LEGAL NOTICE EXETER PLANNING BOARD AGENDA

DATE: March 4, 2020
 TO: David Sharples, Town Planner
 FROM: Jennifer Mates, P.E., Assistant Town Engineer
 RE: PB Case #21404 – 2 Hampton Rd, LLC
 Multi-family Residential Site Plan Review
 Windsor Crossing – Acadia Lane (formerly 2 Hampton Rd)
 Tax Map Parcel #69-3

Date: August 7, 2020
To: Planning Board
From: Dave Sharples, Town Planner
Re: PB Case #20-5 Seacoast Mental Health Center Resource Group
30 Magnolia Lane
Tax Map Parcel # 65-146

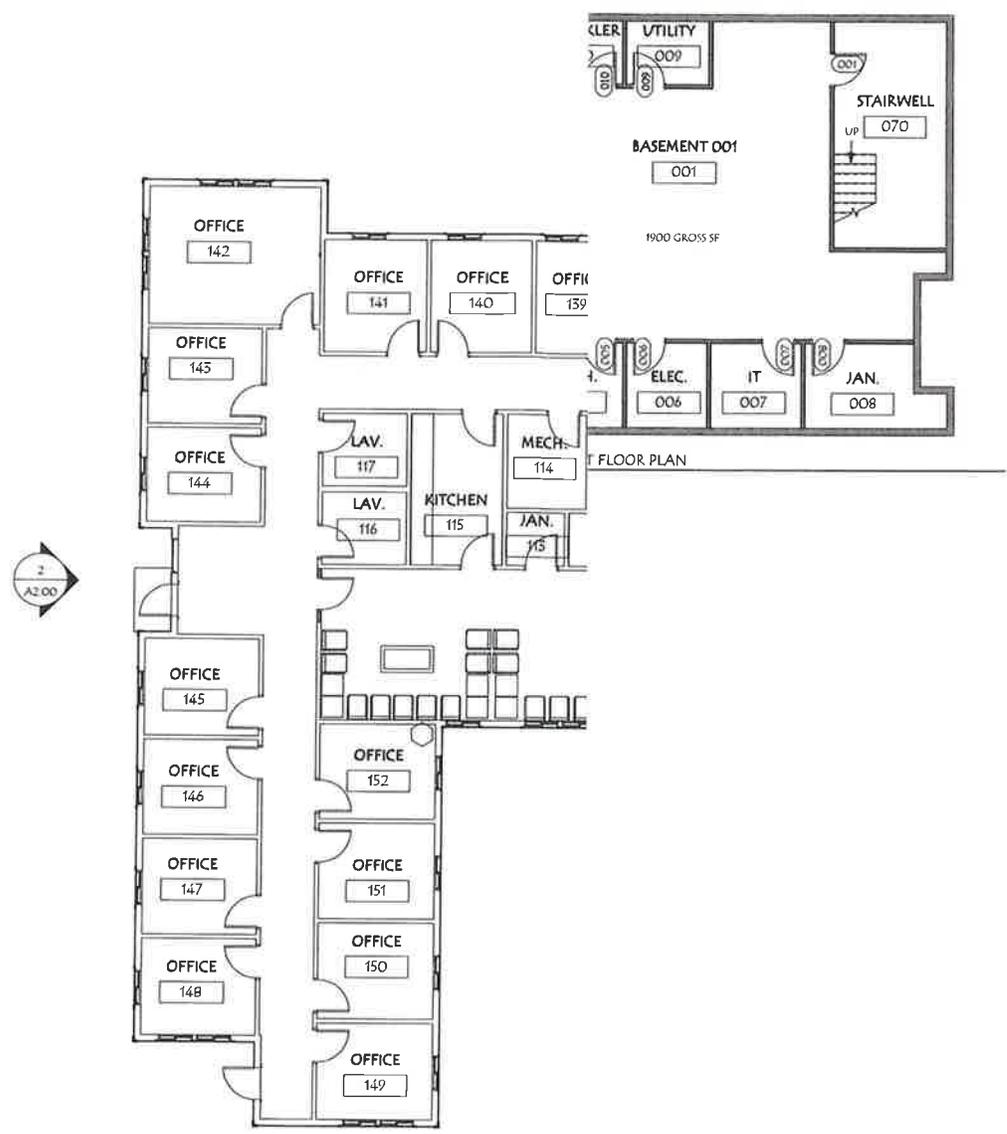
Since Magnolia Lane does not intersect directly with High Street, we believe the planner's comment pertains to the High Street/Buzell Avenue intersection which has the following lane configuration:

Although we do not have current turning movement count data for this intersection, I believe it is highly unlikely that further study would indicate that there is a need for an exclusive right-turn lane on High Street or that two departure lanes are needed on the Buzell Avenue approach to High Street. Right-of-way constraints are apparent at this intersection as well.

While we do not have the data needed to properly evaluate the need for auxiliary turn lanes at these two intersections, we are confident that the incremental increase in traffic from the proposed building addition would not change the results of said analyses. We are equally confident that the traffic increases shown on Figure 2 in our previous memorandum will not significantly alter the prevailing traffic conditions at these intersections.
